**Addendum No. 1  
to the Bidding Documents**

**Recreation Park Improvements Phase 2– East  
Town of Red Hook**

**Issued – January 29, 2020**

ADDENDUM #1  
 EXHIBIT #1  
 SCALE: AS SHOWN

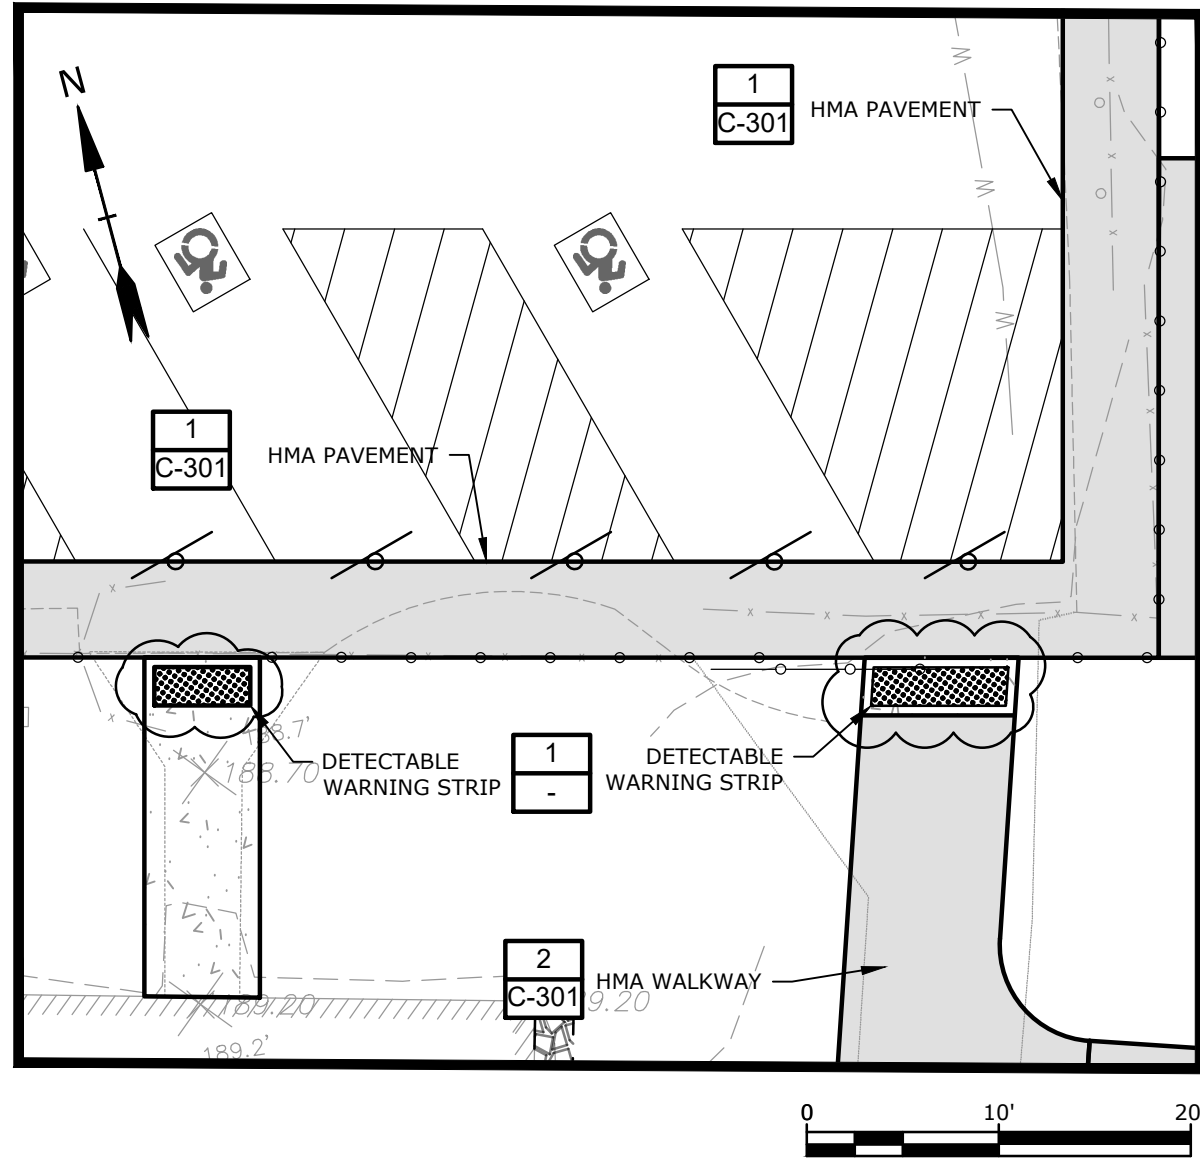
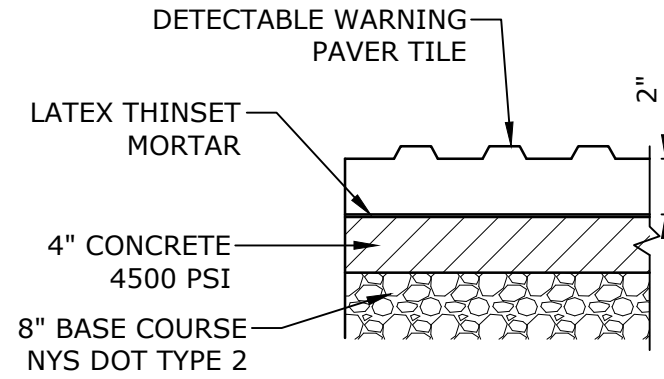
**Item 1-1 Drawing C-201, Sheet 4 of 10 – Proposed Conditions**

**Add** the following to Drawing C-201:

Detectible warning strips shall be provided at the end of both walkways. Please refer to Exhibit #1.

For the Paving areas between the parking bollards and the chain link fence, which paving detail should apply?

Are there any detectable strips needed at transition from park walkways / sidewalks to the parking lot?

*Contractors should refer to detail on 1 on Sheet C-301 (HMA Pavement Detail) for all pavement between the bollards and chain link fence. The HMA walkway shall only be provided on the park side of the chain link fence. Exhibit #1 has been attached for clarification.*

*Detectible warning strips will be required. Exhibit #1 has been attached and show detectible warning strips provided in two locations. The exhibit should be amended to the bidding documents.*
